## ***Interactive comment on “Validation of carbon isotope fractionation in algal lipids as a PCO<sub>2</sub> proxy using a natural CO<sub>2</sub> seep (Shikine Island, Japan)” by Caitlyn R. Witkowski et al.***

Received and published: 6 July 2019

Fig. 1.

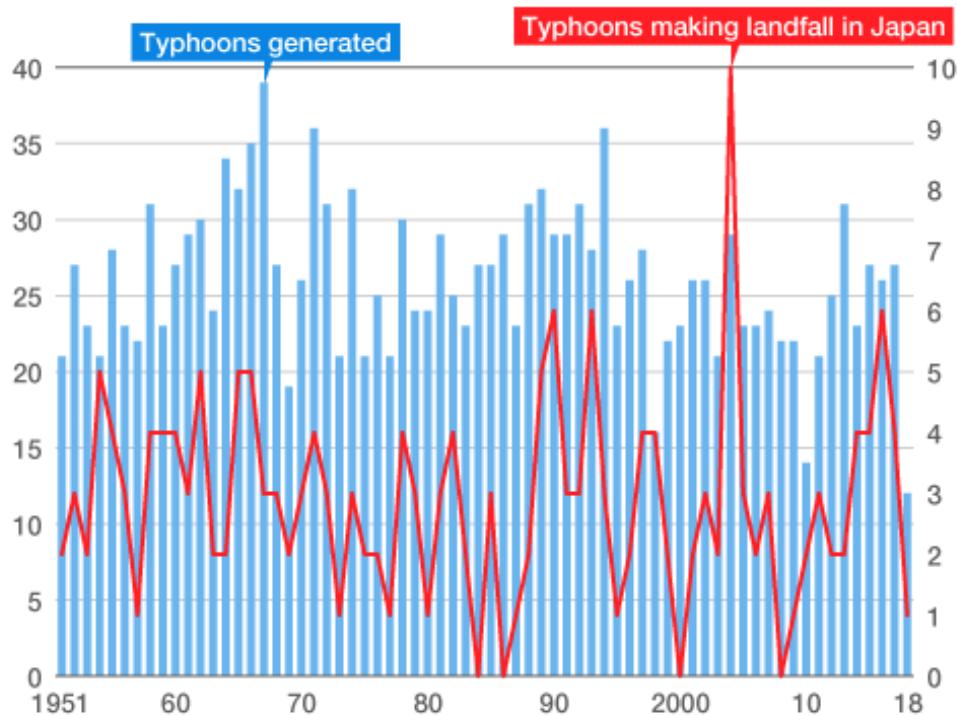
Page 7 Lines 15-25. I find this a bit of a confusing section, particularly in line with the information reported in the method section 2.1. As mentioned earlier I do not understand why the currents and winds were measured in 2014 and 2015 and not in 2016. It now seems that the conditions between the sampling seasons were completely abnormal. In addition, would it be possible to add a few references to information given in this section. I assume that the kind of impact this had on the corals etc must have been properly documented.

\*Based on unpublished observational data from part of the co-authors visiting the site on a monthly basis, the conditions covering 2014-2015 are typical of what they've witnessed over the past six years of research. This study on winds and currents was intensely time-consuming and was thus not repeated here. However, we will add weather station data to further support the normalness of currents and winds in this region of Japan (unfortunately, the only recorded data from this specific island is referenced here). As commented above, typhoons and strong tropical storms are common in this region and occur on an annual basis. Our June collected samples showed a lessened reconstructed value for PCO<sub>2</sub> than the PCO<sub>2</sub> measured at the site, which may be explained by this annual storm season which mixes the bay every year. Mixing during the storm season is a plausible explanation to why we observe a distinct difference between our two sampling seasons (one before the storm season and one after). Our

sampling year (2016) happened to have particularly intense storms reaching land (see supporting figure attached here).
